Subject: The Draft Guidance for Industry and Food and Drug Administration Staff, from the document: **Hospital Bed System Dimensional Guidance to Reduce Entrapment** issued August 30, 2004.

Comments and suggestions regarding the draft guidance for Industry and Food and Drug Administration Staff, from the document: **Hospital Bed System Dimensional Guidance to Reduce Entrapment**.

FIGURE 1

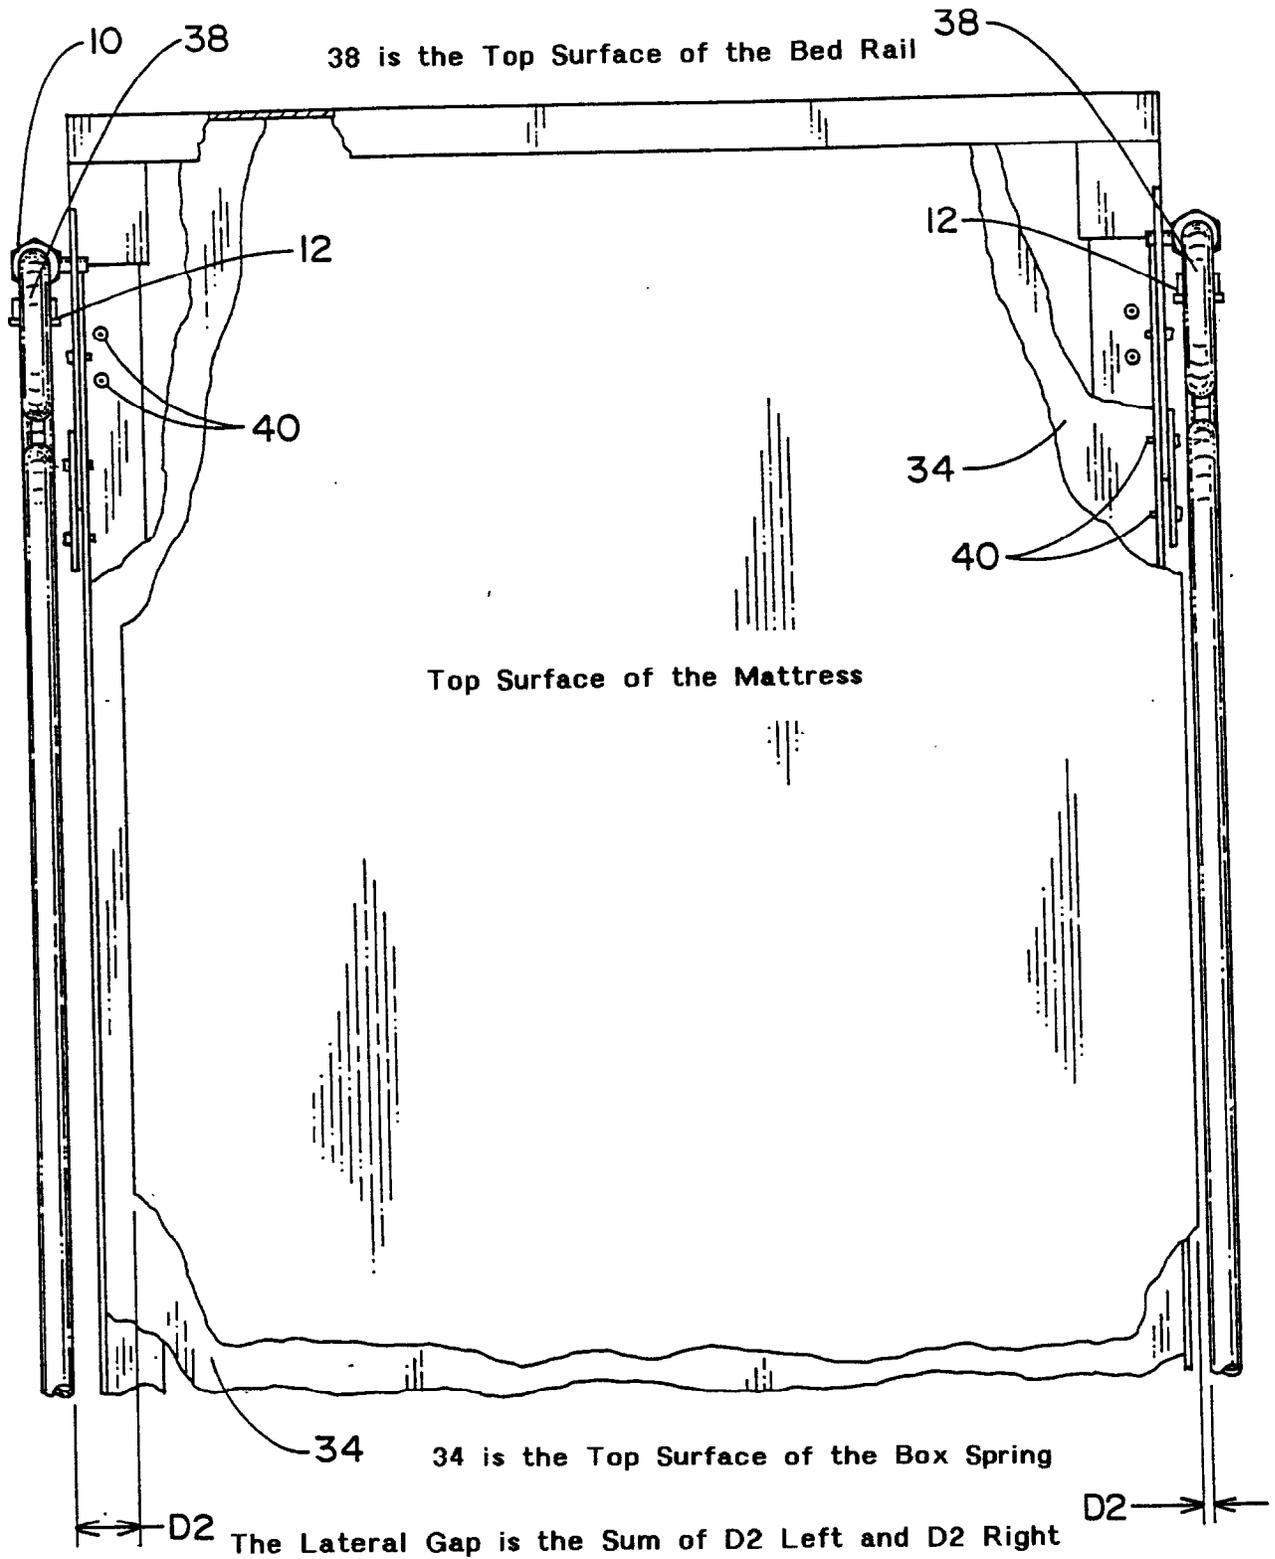
Of greater concern is the fact that the width of mattresses, twin beds with bed rails and attachment hardware have been omitted from this draft Guidance. This State's Checklist, Attachment #1, clearly recognizes the contribution that a mattress of the proper width can make in preventing bed rail entrapments. Checkpoints # 2, #3 and # 18 focus on the width and performance of the mattress. See Figure #1.

Regrettably, only split side rails have been used to exemplify entrapment possibilities. Split side rails fail to demonstrate the full entrapment potential within Zone 3 that is present when full-length side rails are used, see Figure 1. Accordingly, the belief that the head blocks the entry of the neck into this gap is not true. With full length side rails, the legs slide between the side rail and the mattress and the weight of the legs pulls the trunk through the Zone 3 gap until either the chest or the head becomes entrapped.

FIGURE 2

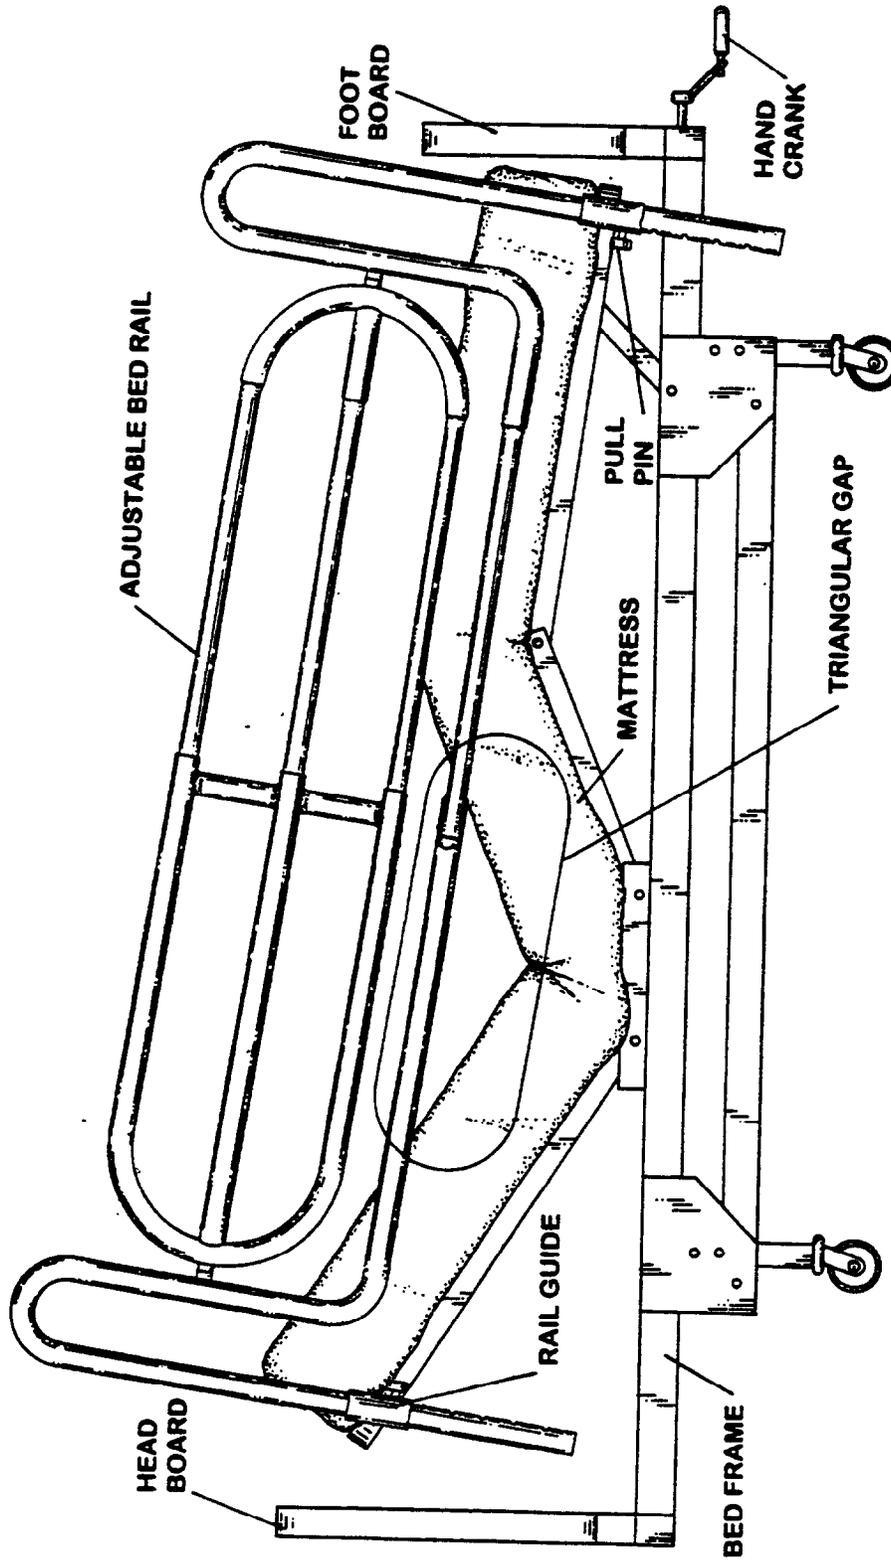
Comment #7 relating to articulated bed positions, page 23 of the draft. Most entrapment deaths in hospital beds take place when the head of the bed is elevated. The under bar entrapment potential of Zone 2 is significantly exacerbated when a full length bed rail is being used, see Figure 2. This Figure is taken from the User's Guide for the Bed Safety Checklist to illustrate Checkpoint #20, which states that:

"With the head of the bed raised, the triangular space between the bottom side rail and the mattress is not large enough to entrap a person."

As noted by the obvious entrapment hazard identified in Figure 2, I am strongly suggesting that the FDA include guidance for under bar gaps in articulated beds and particularly for those articulated beds with full length rails.
